APPARATUS AFFECTED: 35 Typing and Nontyping Reperforator Units (LPR and LRPE), 37 Typing and Nontyping Reperforator Units (YPR and YRPE) and 35 Typing and Nontyping Perforators (LKTP and LKPE) equipped with Power Drive Backspace Mechanism.

REASON FOR REISSUE: The backspace eccentric drive mechanism cover, previously provided as a customer option, is added to units listed under APPARATUS AFFECTED, as manufactured at Teletype and to change classification from D to A.

UNITS EQUIPPED WITH TP170193 BACKSPACE MECHANISM COVER

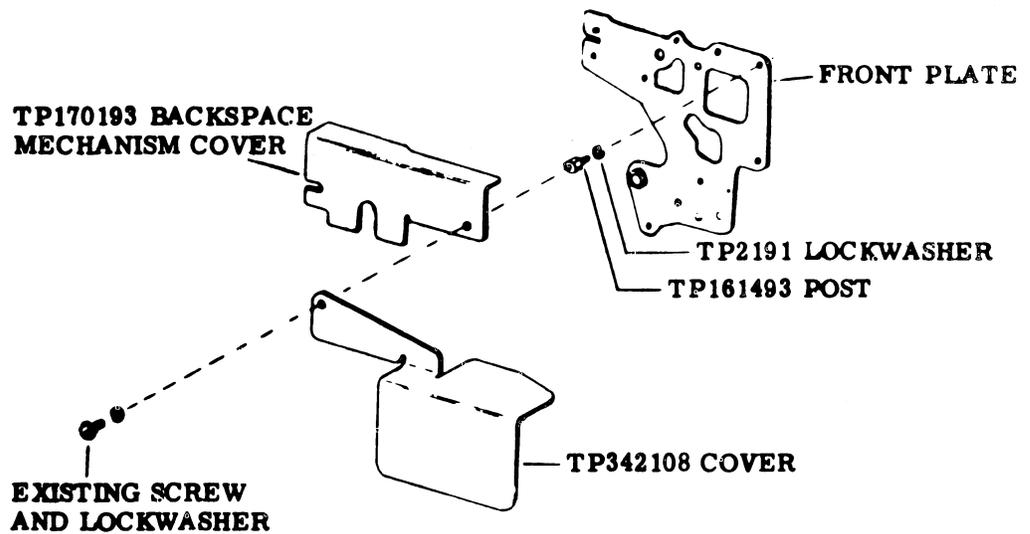
CHANGE: A TP342108 cover is added, mounted (using existing hardware) in the upper right corner hole of the front plate. On units equipped with TP170193 backspace mechanism cover, the TP342108 cover is assembled to the TP161493 post. On units equipped with the TP178930 backspace mechanism cover, the TP342108 cover is assembled to the TP178932 post.

(2) The TP343954 modification kit is shown in Section 574-224-800, Issue 4, Page 15; however, if the TP343954 modification kit is added to units equipped with the TP170193 backspace mechanism cover, the TP342108 cover is assembled to the existing TP161493 post (not the TP178932 post furnished in the modification kit). See upper figure on Attachment Sheet 1.

INSTALLATION INSTRUCTIONS

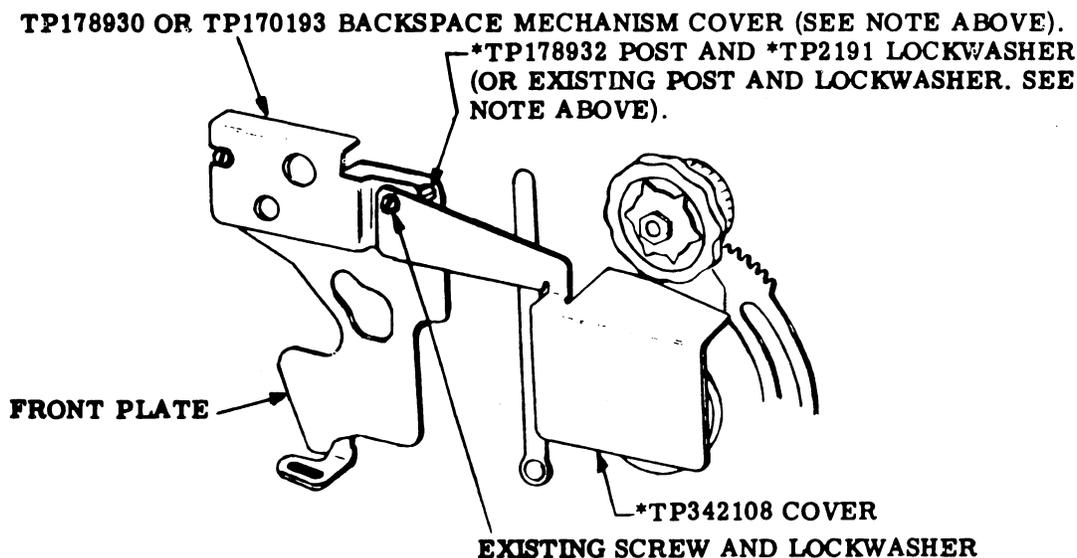
- (1) REMOVE THE SCREW AND LOCKWASHER FROM THE UPPER RIGHT CORNER HOLE OF THE FRONT PLATE AND REPLACE WITH THE TP178932 POST AND TP2191 LOCKWASHER.
- (2) ASSEMBLE THE TP342108 COVER TO THE TP178932 POST, UTILIZING THE SCREW AND LOCKWASHER PREVIOUSLY REMOVED.

NOTE: IF THE TP178930 OR TP170193 BACKSPACE MECHANISM COVER IS PRESENT, DISREGARD PARAGRAPHS (1) and (2) AND DISCARD THE TP178932 POST AND TP2191 LOCKWASHER FURNISHED IN THE MODIFICATION KIT. ASSEMBLE THE TP342108 COVER AND THE BACKSPACE MECHANISM COVER TO THE EXISTING POST AS SHOWN.

- (3) ALIGN THE TP342108 COVER IN A HORIZONTAL PLANE OVER THE BACKSPACE ECCENTRIC DRIVE MECHANISM, MAKING SURE THE COVER CLEARS THE HIGH PART OF THE ECCENTRIC DRIVE MECHANISM. TIGHTEN THE MOUNTING SCREW SECURELY.
